WASTEWATER BASIS OF DESIGN REPORT

Museum Square Building 4 Scottsdale, Arizona

FINAL Basis of Design Report

7108 E. 2ND STREET
PRELIMINARY UTILITY PLAN
SCOTTSDALE, ARIZONA 85251

9990009e-UT.dwg
UT1
1 OF 1 SHEETS

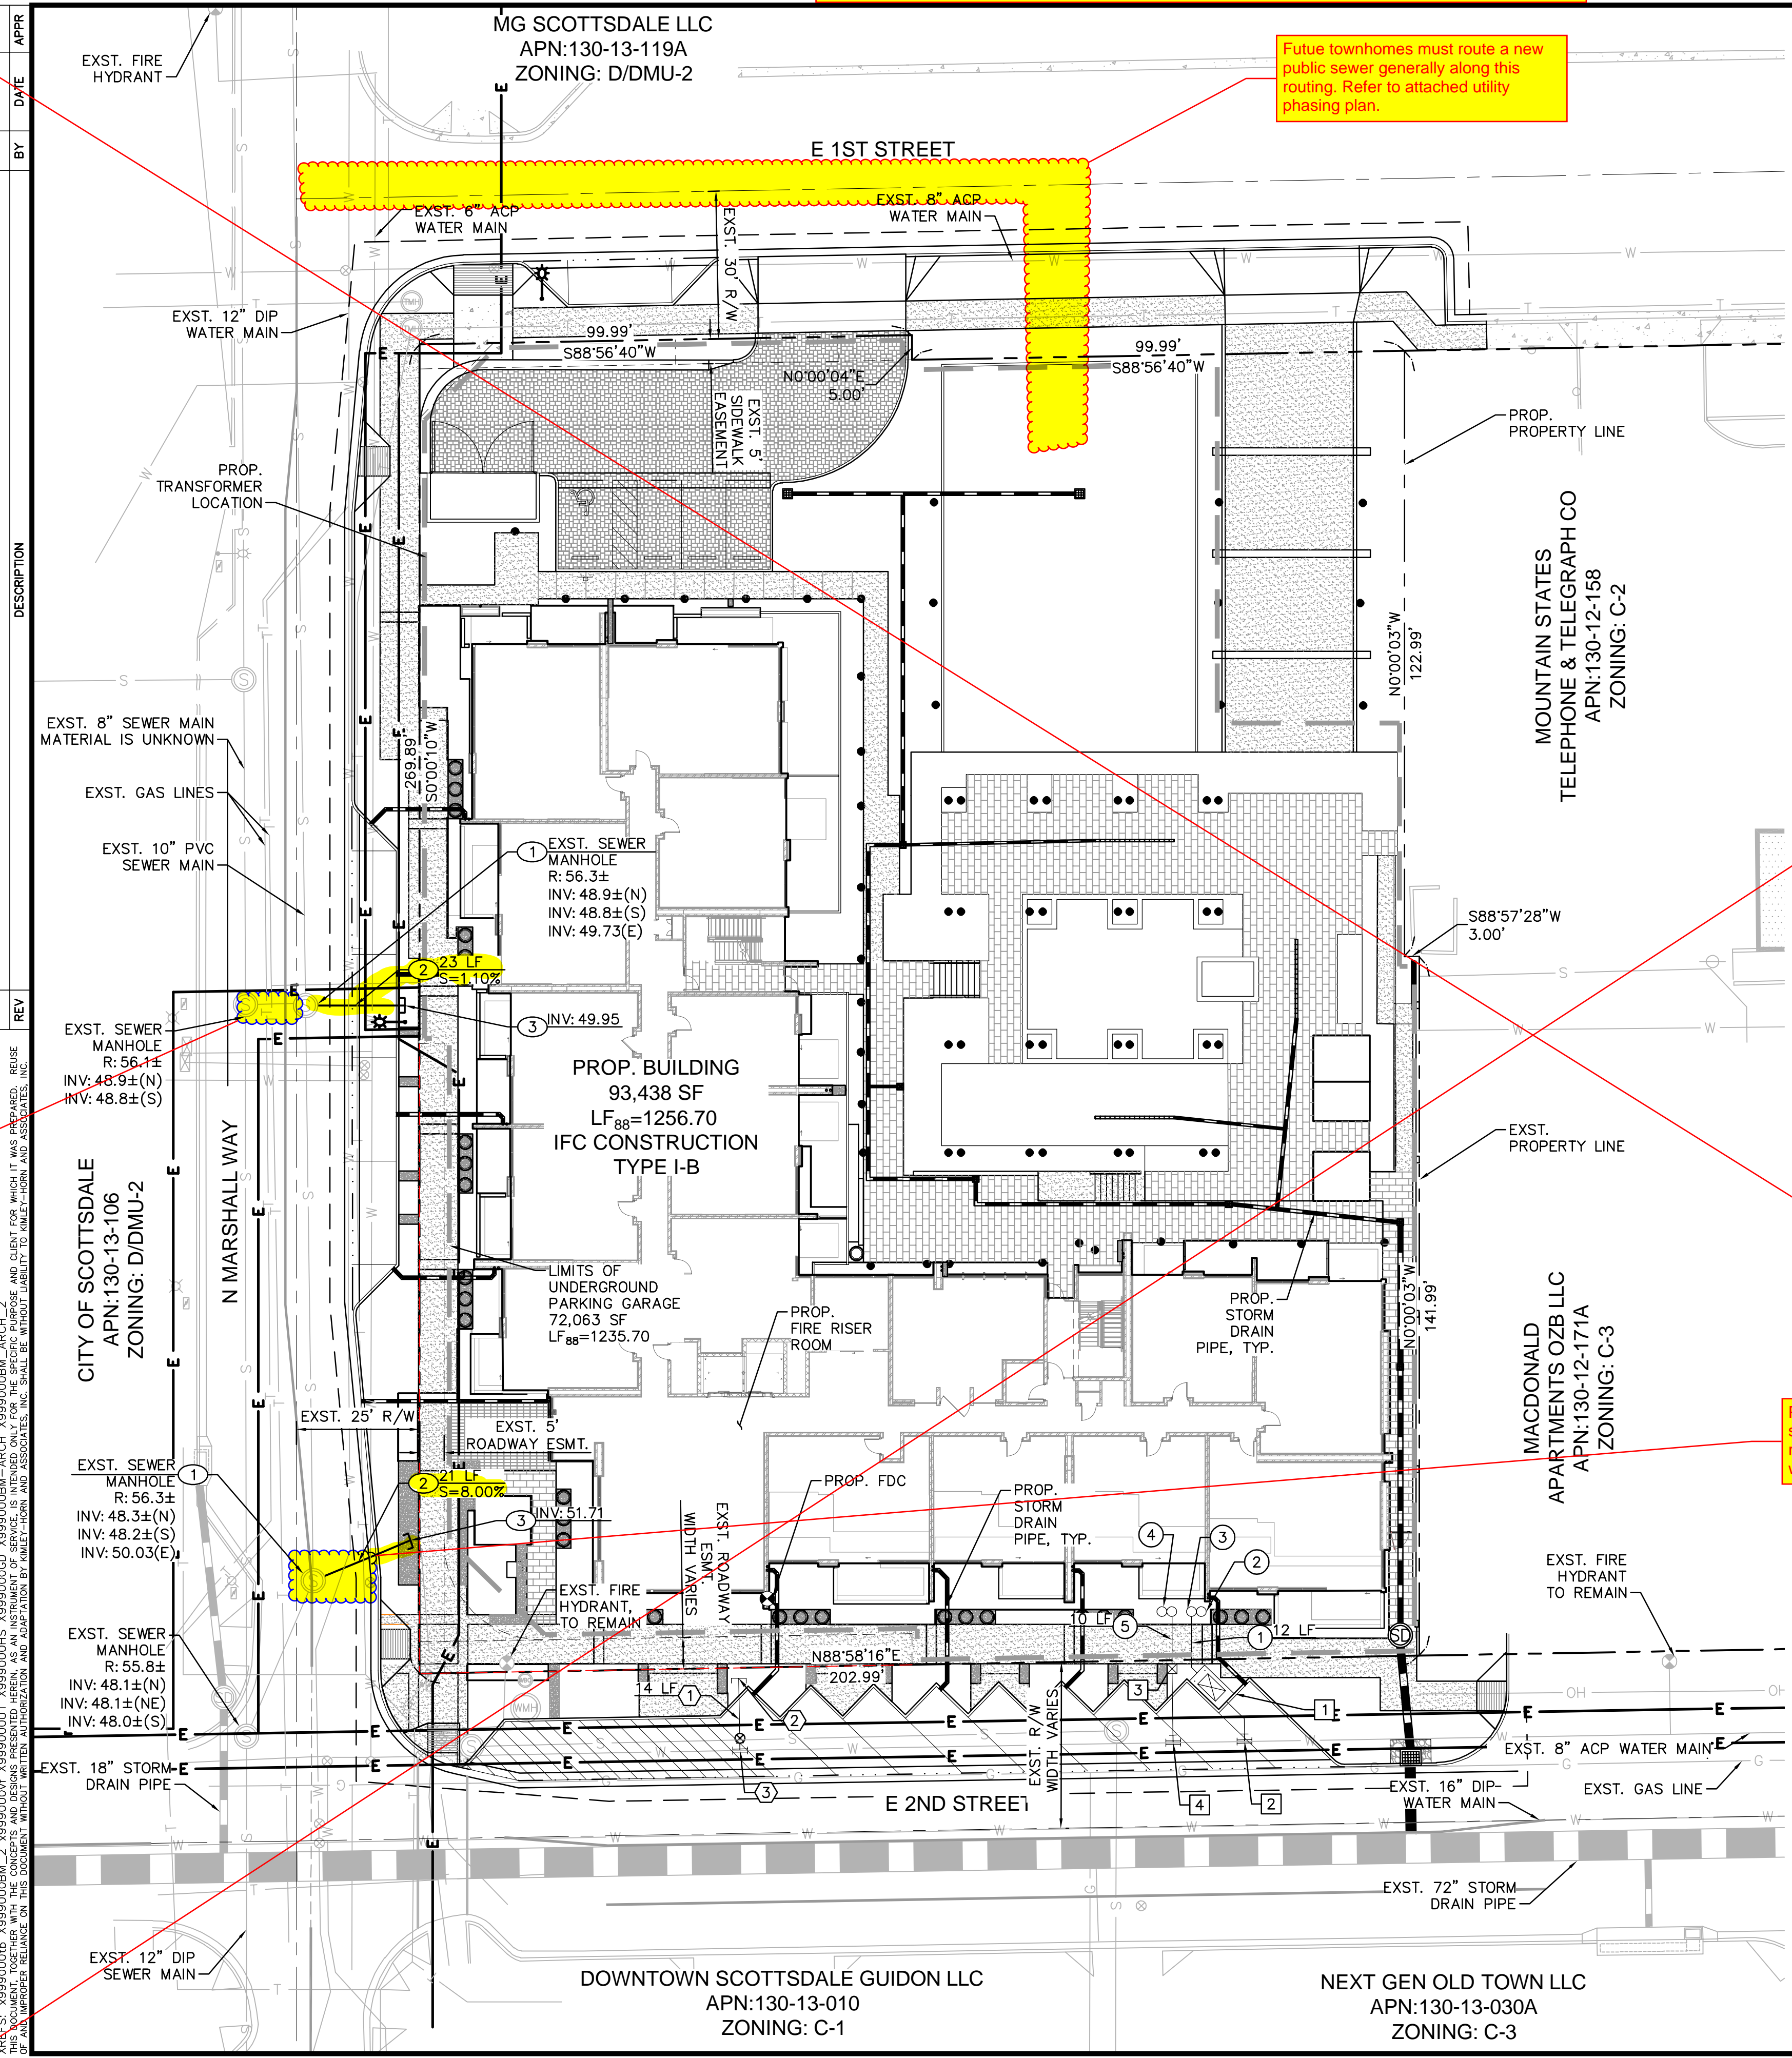
Future townhomes must route a new public sewer generally along this routing. Refer to attached utility phasing plan.

Shall be per MAG 440-3. Two-way likely acceptable also. Call out MAG detail.

Still in place? confirm on plans. Could be left as emergency reliever is high enough above eastern sewer inverts.

Pool backwash should be routed to this service line, even better would be to route it to the manhole to the south, where sewer changes to 12"

7108 E. 2ND STREET
DEMOLITION PLAN
SCOTTSDALE, ARIZONA

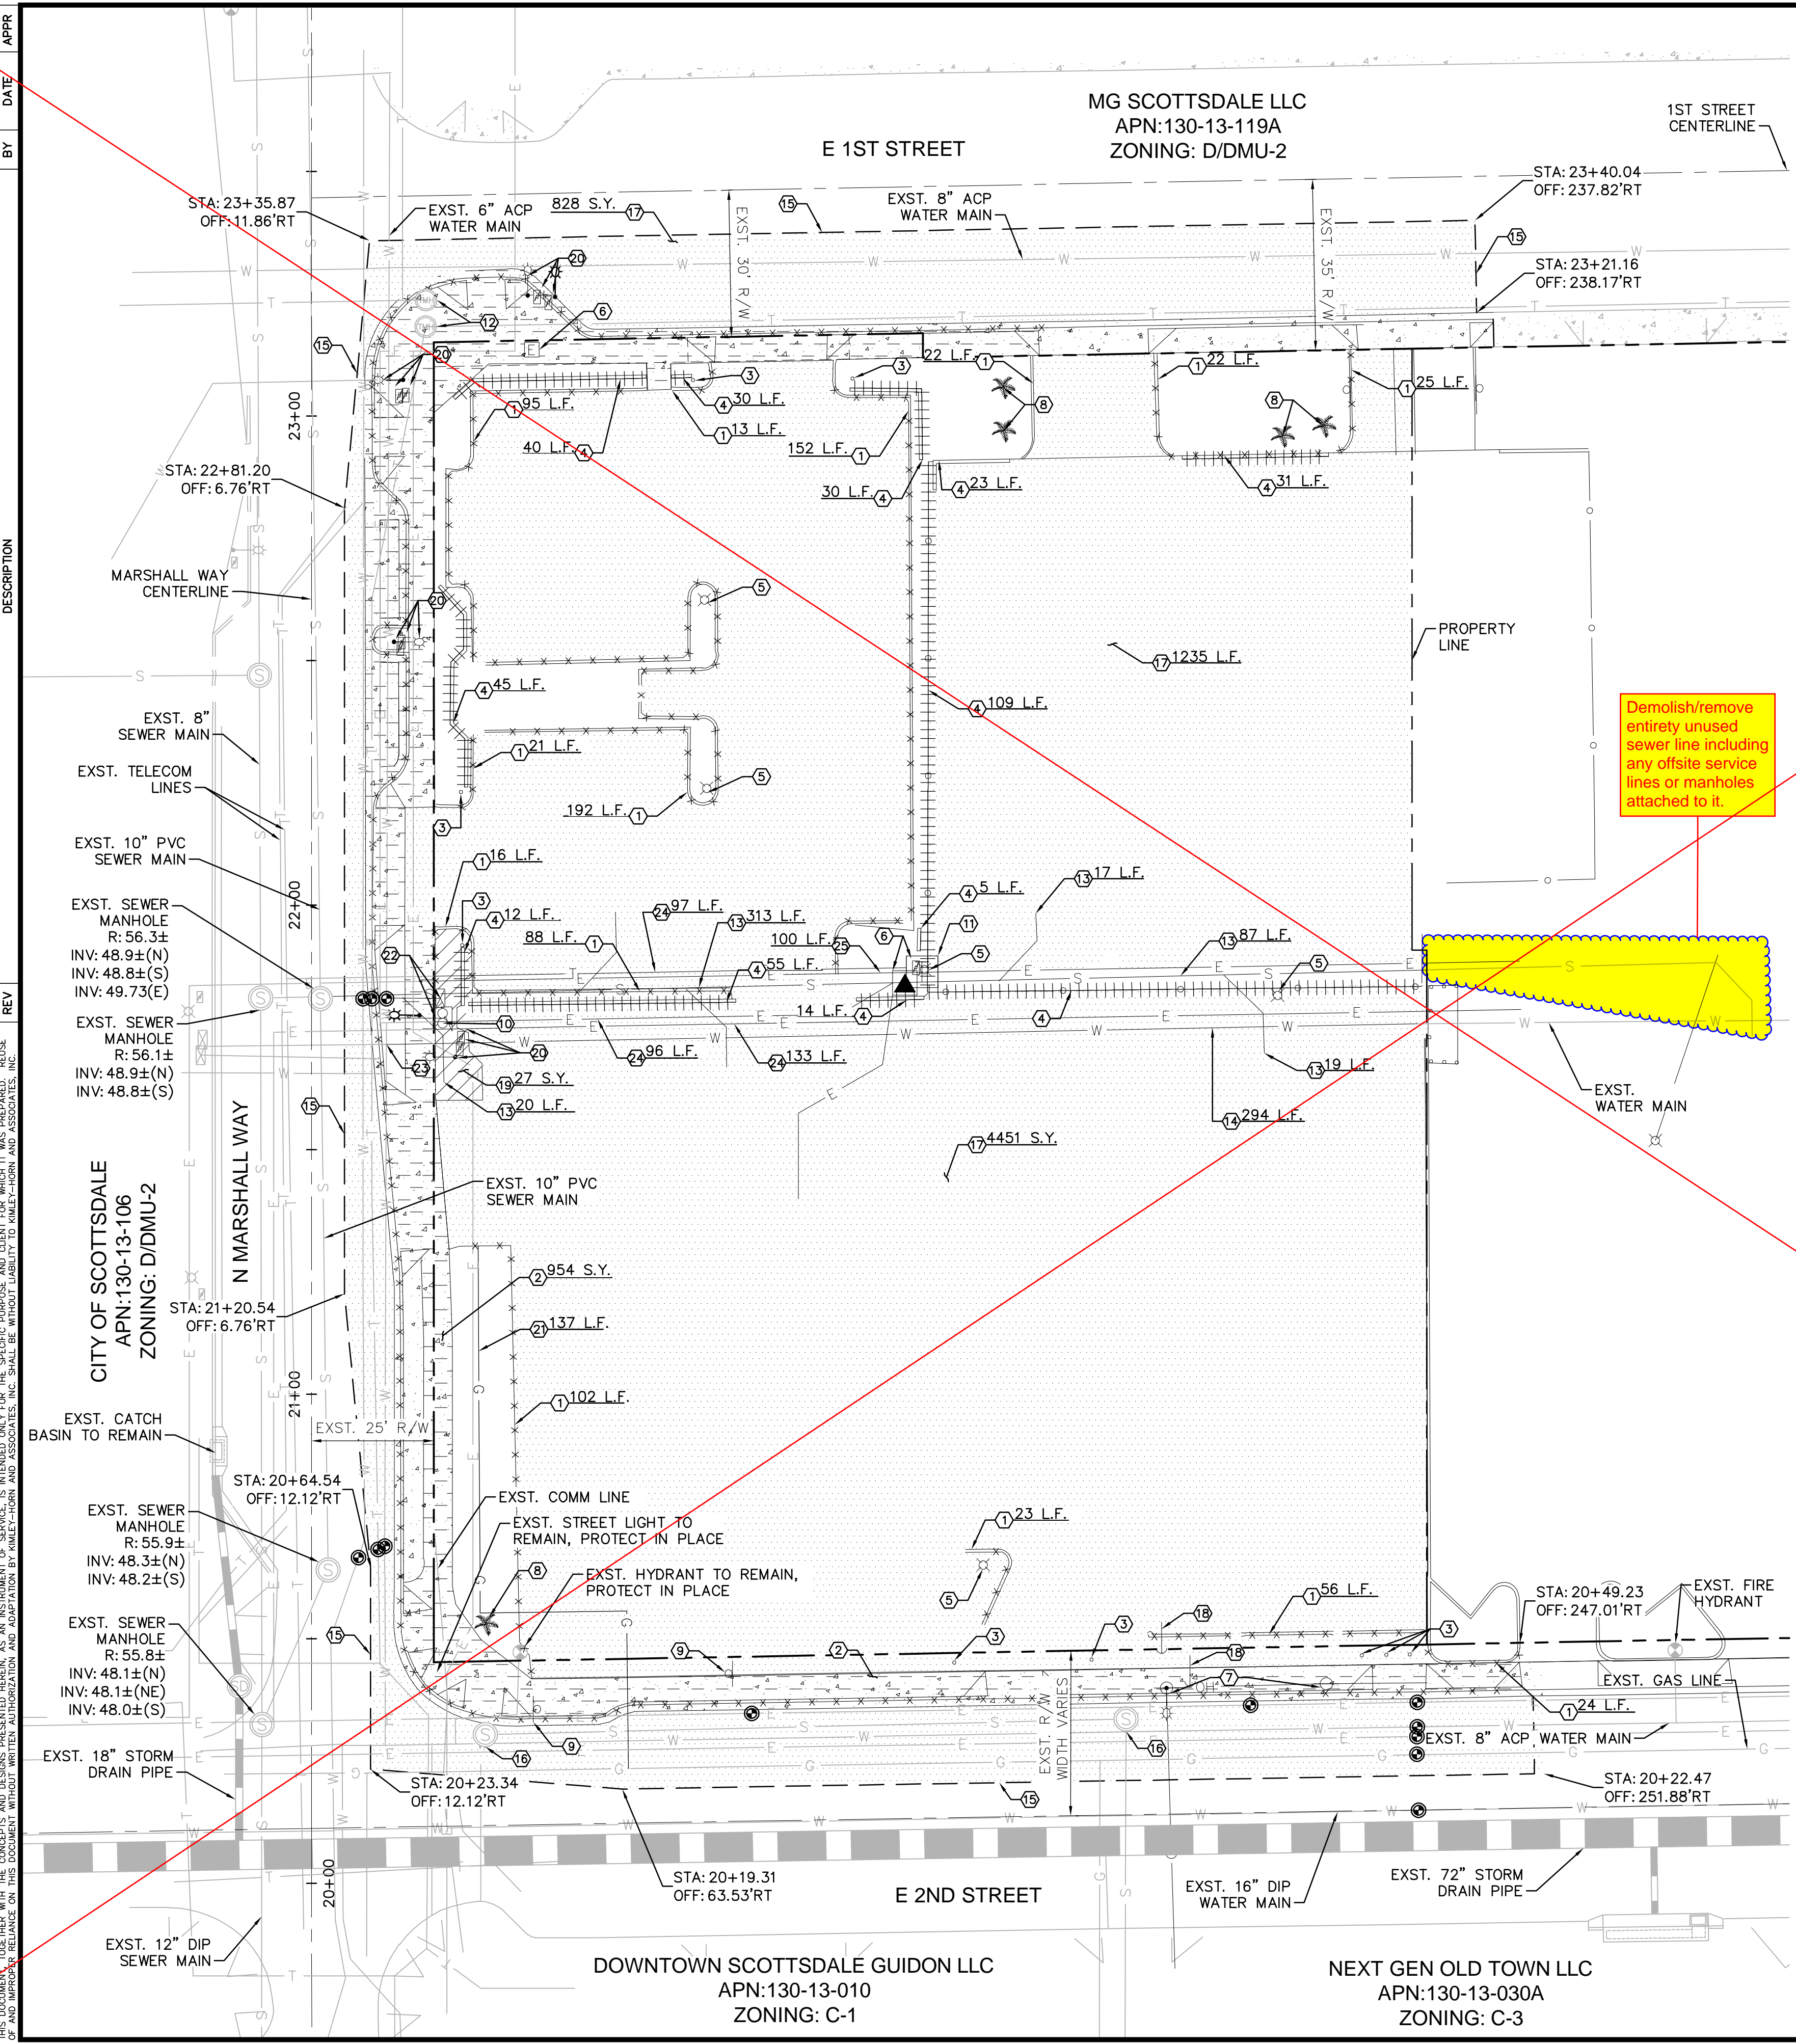
Demolish/remove entirely unused sewer line including any offsite service lines or manholes attached to it.

SHEET NO.: C4.00

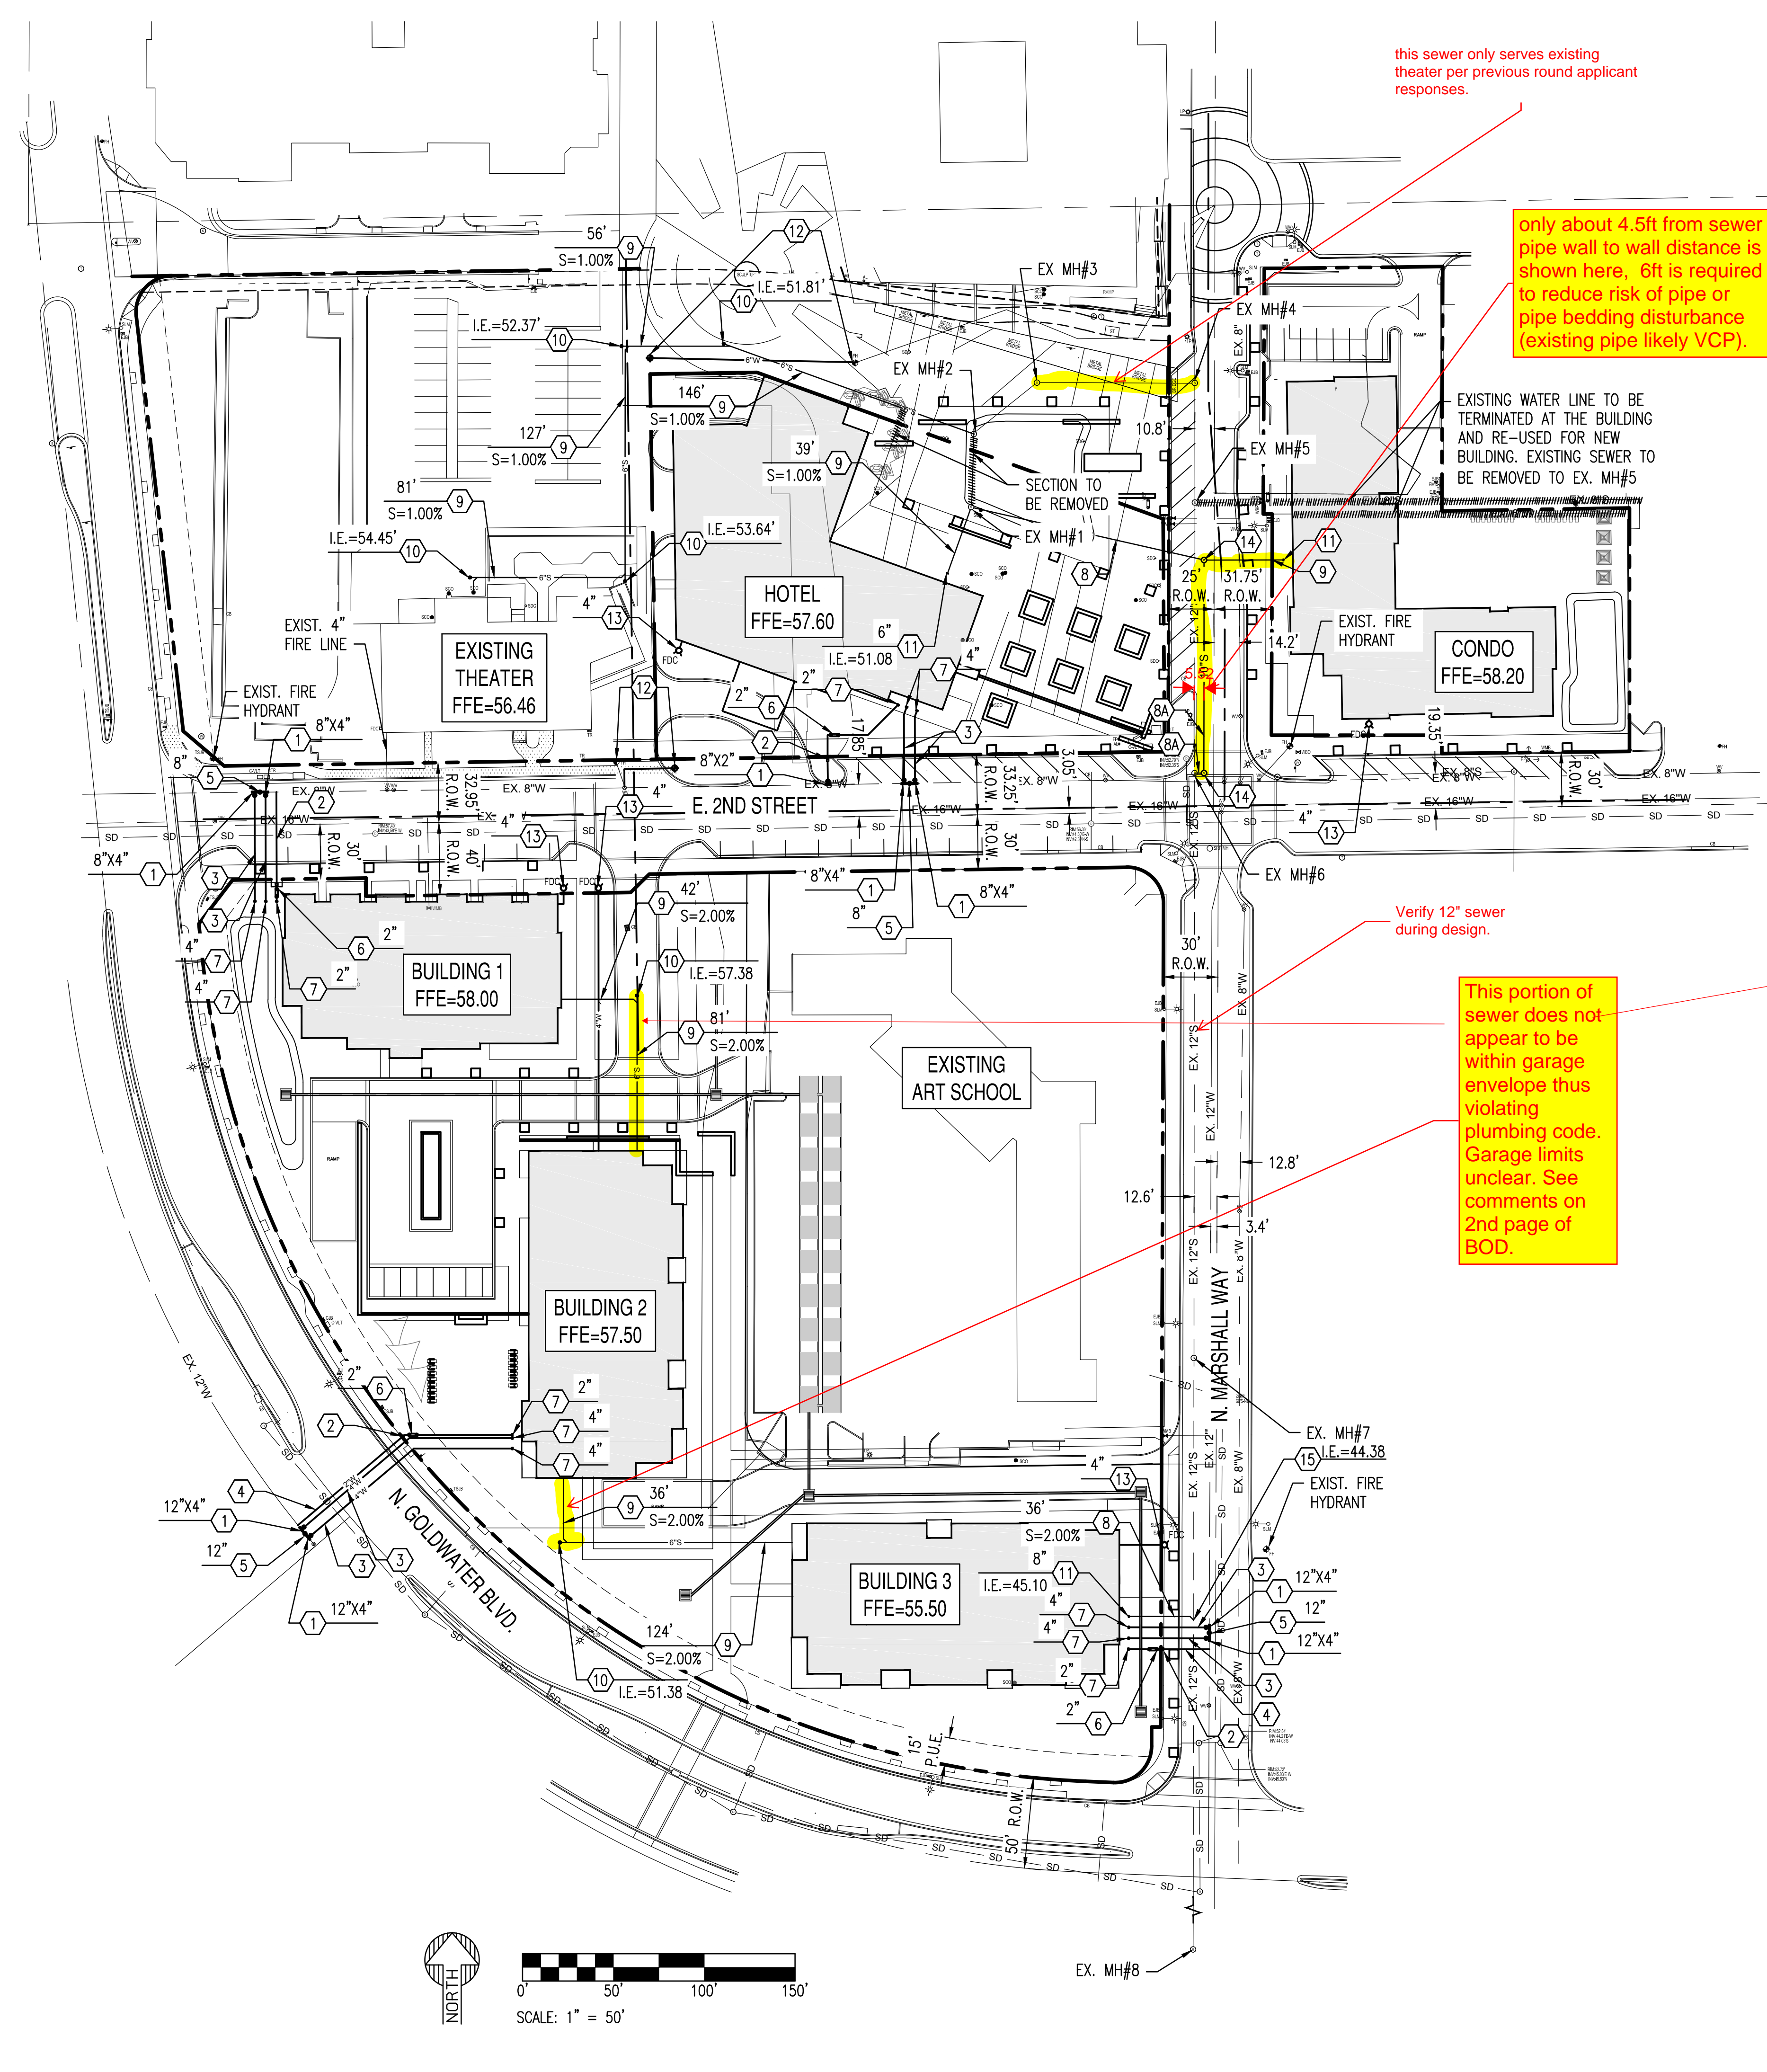
this sewer only serves existing theater per previous round applicant responses.

Verify 12" sewer during design.
